2ND AND VIRGINIA

A new mixed-use hotel, residential, and co-working building will be located at the corner of 2nd Avenue and Virginia Street in downtown Seattle. The building will be a vibrant addition to this key intersection and will take design cues from the existing landmark on site and the urban patterns of buildings and pedestrian experiences that make up the Belltown neighborhood.

RESPONSE TO BOARD GUIDANCE

DEPARTURE 1

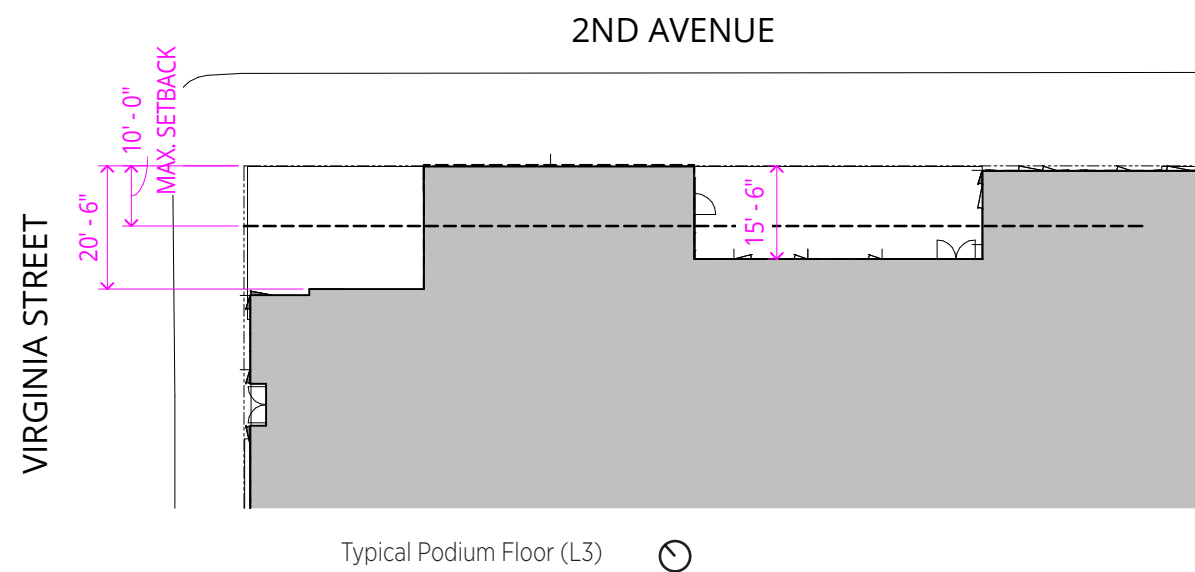
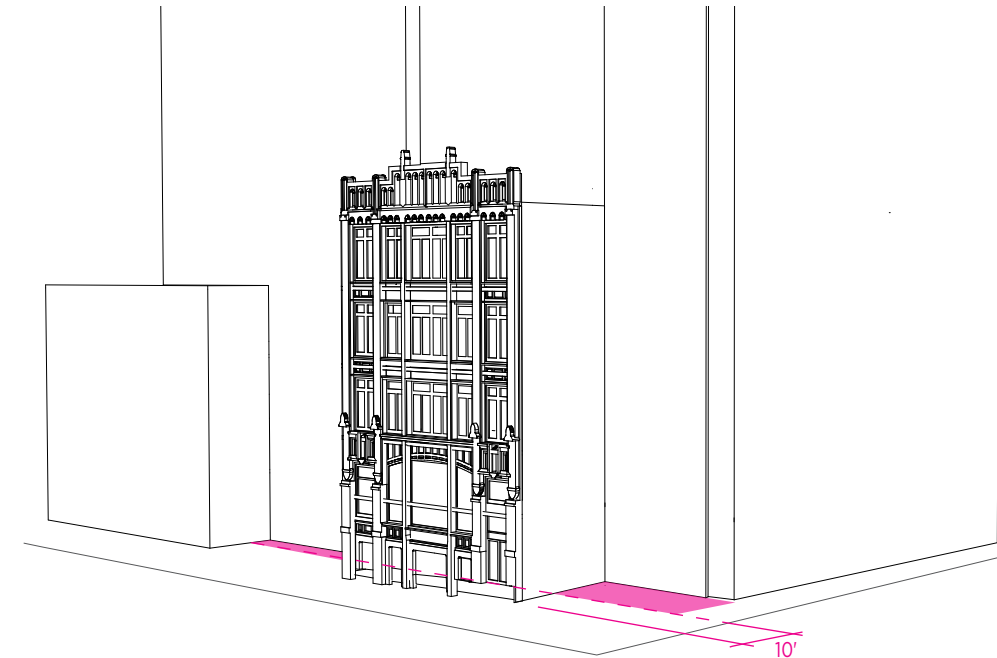
The Board indicated preliminary support for the requested departure as the proposed setbacks provide additional relief for the existing landmark structure, as well as creating opportunity for enhanced entry experiences. (B-2 Create a Transition in Bulk and Scale, B-3 Reinforce Positive Urban Form & Arch. Attributes, D-1 Provide Inviting and Usable Open Space)

A departure is requested to setback the facades surrounding the Terminal Sales Annex (TSA) greater than 10'. We are requesting 15' on the south and 20.5' on the north.

South of the TSA: The #1 priority of the Landmarks Preservation Board (LPB) is to set back the new tower from the landmark structure. In conversations with the ARC over the years, a 15' setback is a reasonable starting point for tower setback from the Landmark. In this location, which supports our overall design concept, the tower form comes down the ground thus creating the 15' setback.

North of the TSA: As the tower begins to telescope and step back from the Landmark, the setback dimensions transition from 15' to 22' at the corner. This tower setback allows visibility to the Terminal Sales Annex and creates a grand open space to denote entry and respite for pedestrians.

DEPARTURE 2

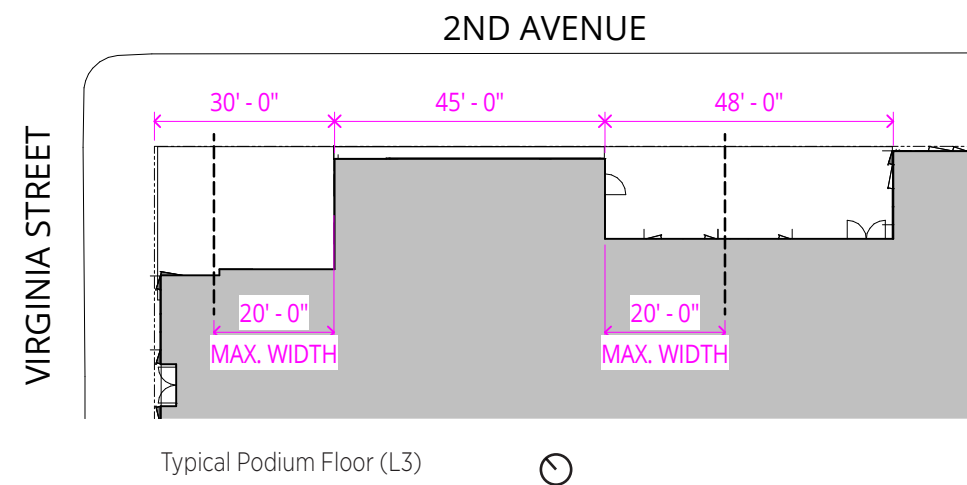
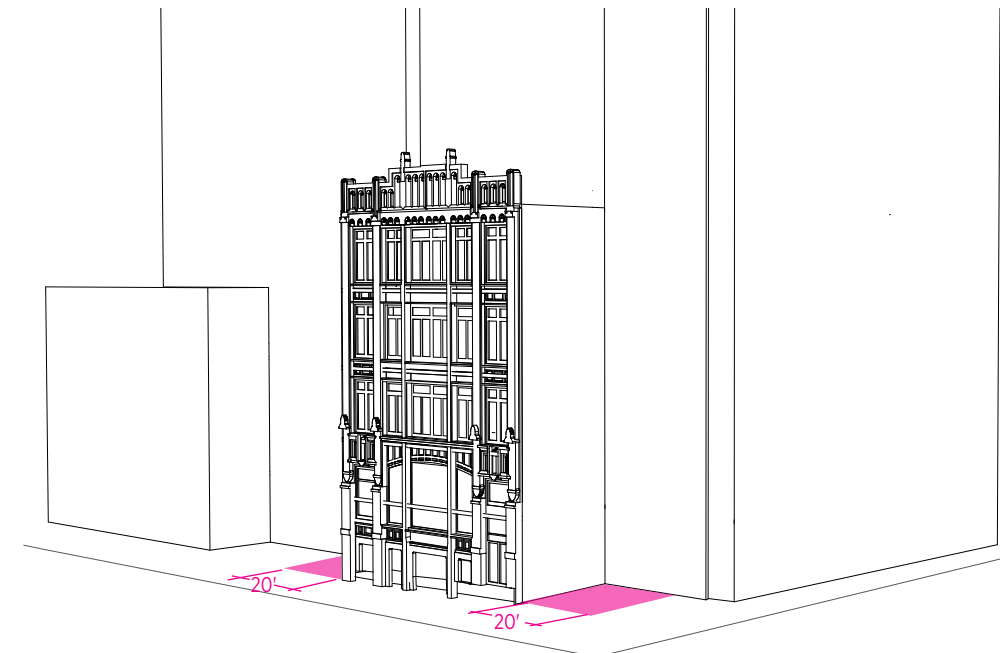
The Board indicated preliminary support for the requested departure as the proposed setbacks provide additional relief for the existing landmark structure, as well as creating opportunity for enhanced entry experiences. (B-2 Create a Transition in Bulk and Scale, B-3 Reinforce Positive Urban Form & Arch. Attributes, D-1 Provide Inviting and Usable Open Space)

A departure is requested to increase width of setback to relate to the TSA on the south, while opening the corner to Landmark on the North. We are requesting 43' on the south and 30' on the north.

South of the TSA: The width of the setback on the south of TSA is directly related to the width of the TSA itself. The TSA is approximately 45' wide and the width of the setback is approximately 48'. This width also is directly related to the proportions of the tower's telescoping form concept.

North of the TSA: To create a corner open space and for the Landmark to 'front' the corner, a greater setback is required. This corner open area reveals the lower edge of the tower as it descends from above, hovering just above ground at the main entry.

DEPARTURE 3

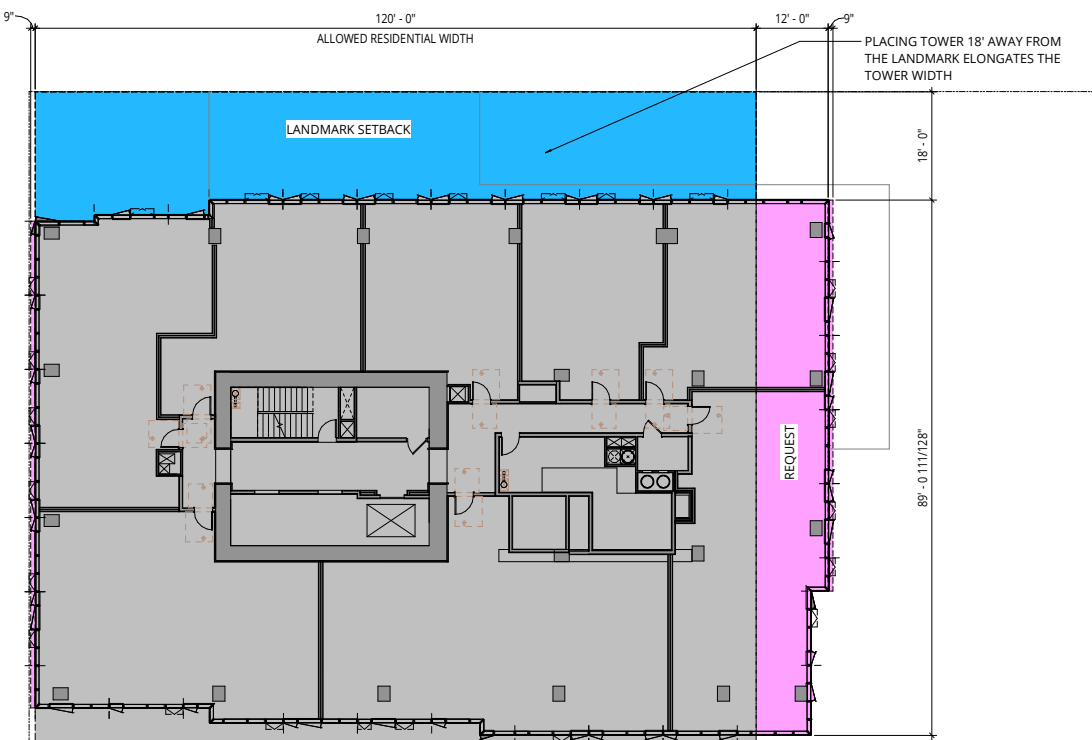
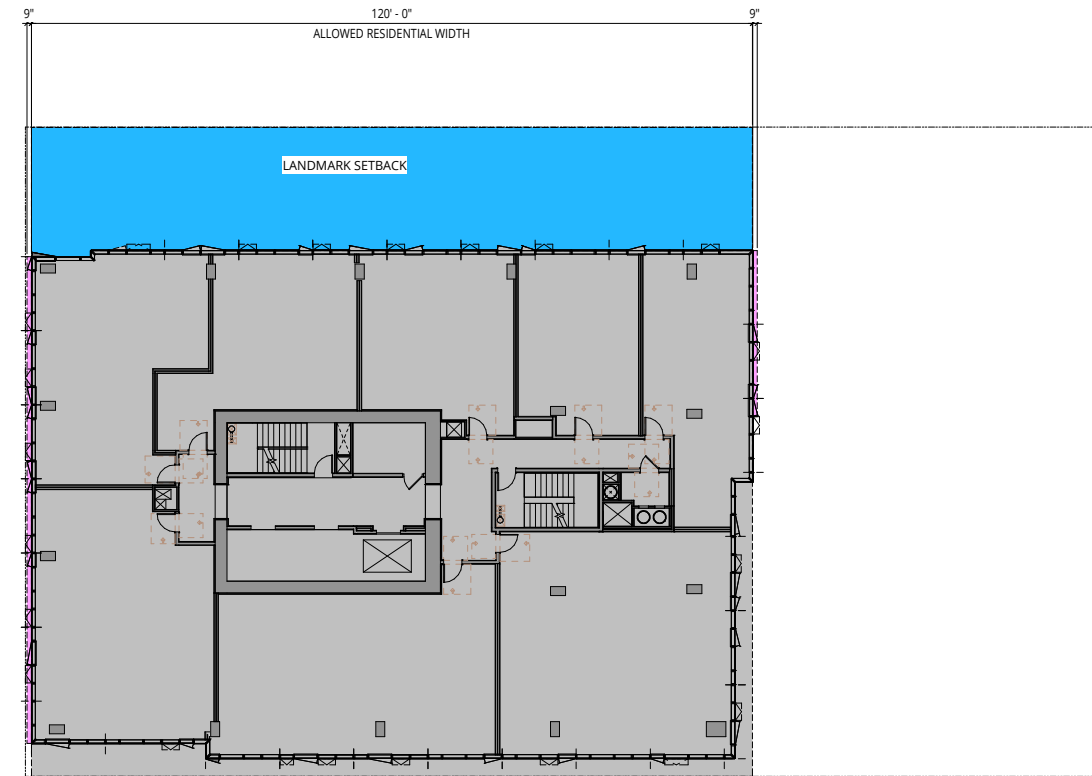
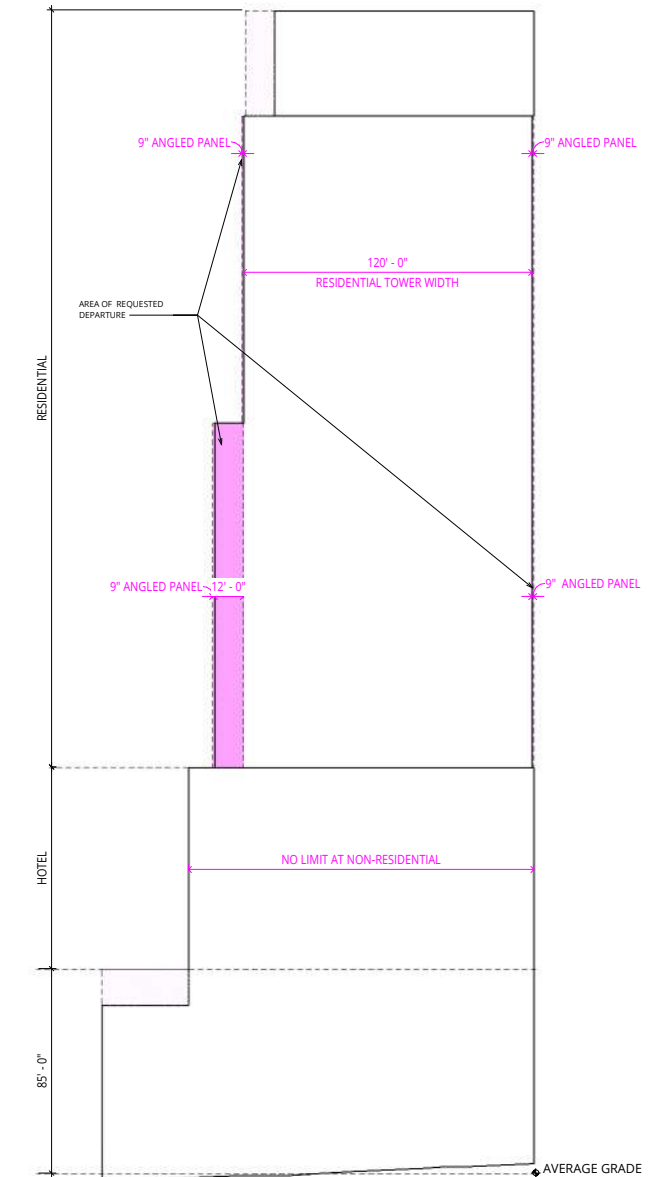
The Board indicated they preliminary support for the requested tower width departure, as the increased width reinforces the design of the tower stepping and enhances the scaling moves in the upper tower levels. The Board also noted they appreciated the reduction in the departure request, which should be maintained moving forward. (A2.1. Desired Architectural Treatments, B1 Respond to the neighborhood context, B-2 Create a Transition in Bulk and Scale, B-3 Reinforce Positive Urban Form & Arch. Attributes)

A departure is requested to extend the residential portion of the tower by 12' at the widest section.

The current maximum facade width is not ideal for the historic landmark on site. When the tower sets back from the landmark, it immediately creates a more rectangular tower which does not allow an average tower plate of 10,700sf without increasing the overall width. By setting the entire tower back from the landmark by 18', it essentially widens the tower to create an average residential footprint of 10,500sf.

- The overall tower width has been reduced to 120'-0" at Level 30
- The total average floor plate is 10,500 sf, 200 sf under the maximum floor plate allowed.

DEPARTURE 4

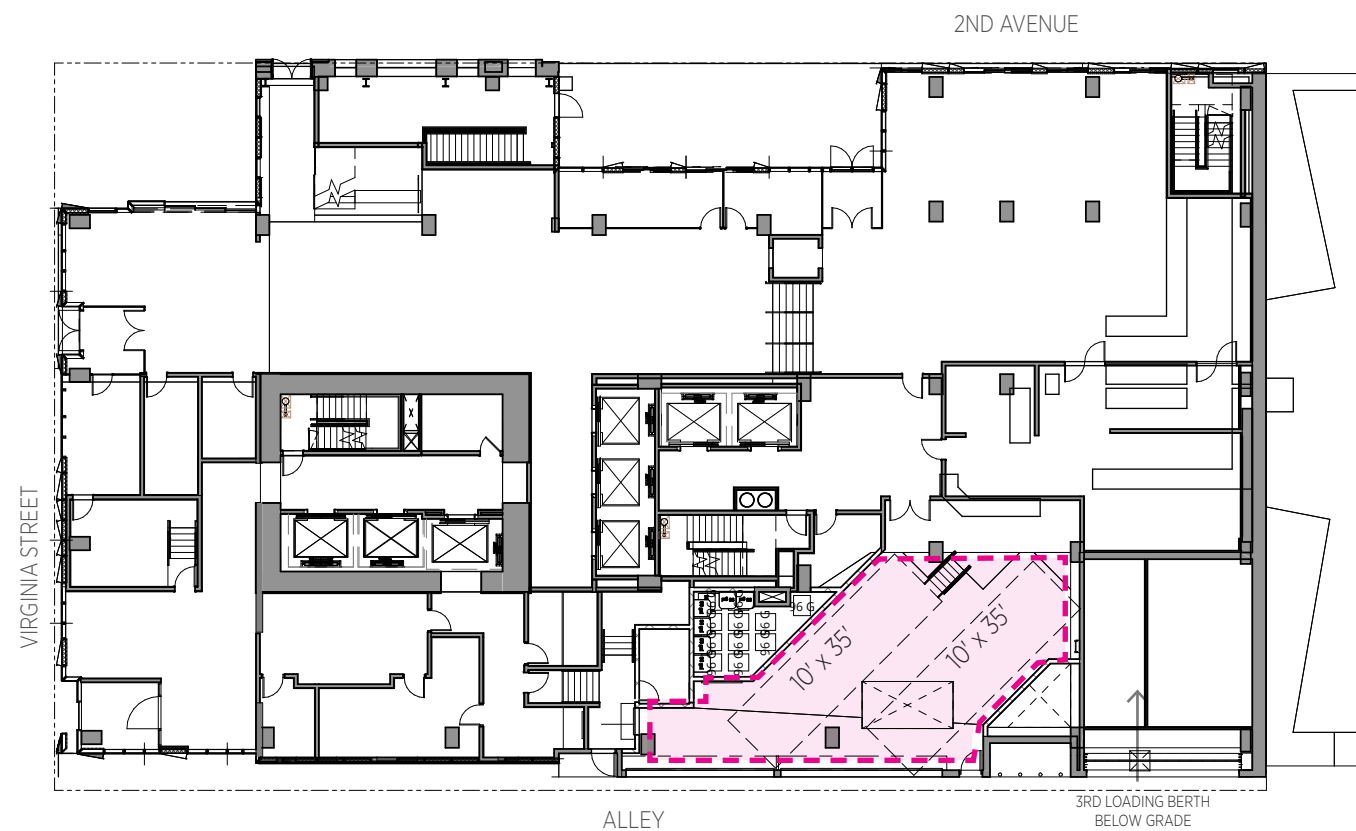
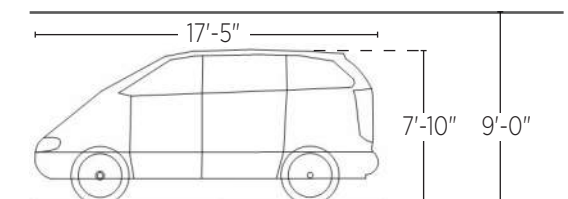
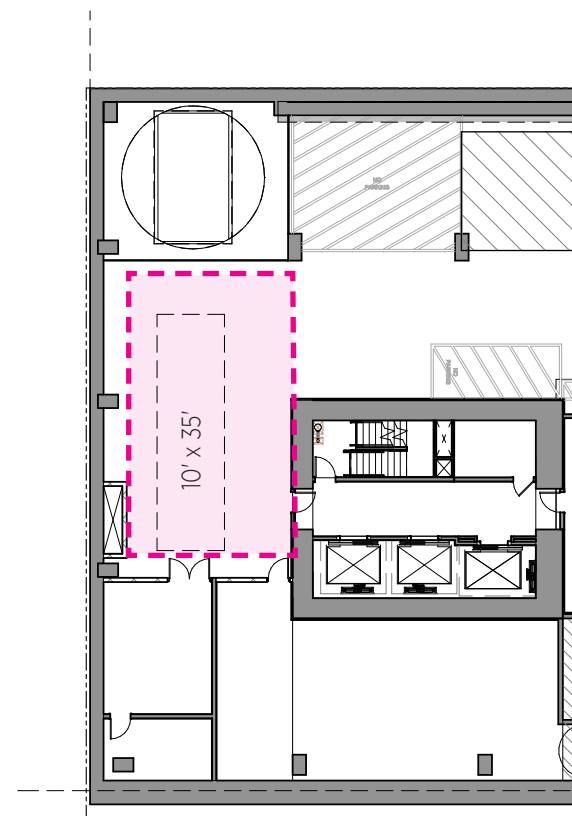
The Board indicated they preliminary support for the requested departure, as they supported an interior loading space completely off the alley. (C1 Promote Pedestrian Interaction, C6 Develop the Alley Façade, E1 Minimize Curb Cut Impacts, E3 Minimize the Presence of Service Areas)

Three full width and length (10' x 35') loading berths are provided. A departure is requested to reduce the height of one of the three required loading berths to 9'-0".

Quantity and size can be reduced by Director's Rule, Type 1 Decision, however there is no provision for height. At EDG, a third full size loading berth was provided in the porte cochere area. In order to minimize curb cuts and the presence of service areas, the third loading berth has been moved to the first parking level allowing more active uses off of Virginia Street. This loading berth will be used by smaller delivery and moving vans.
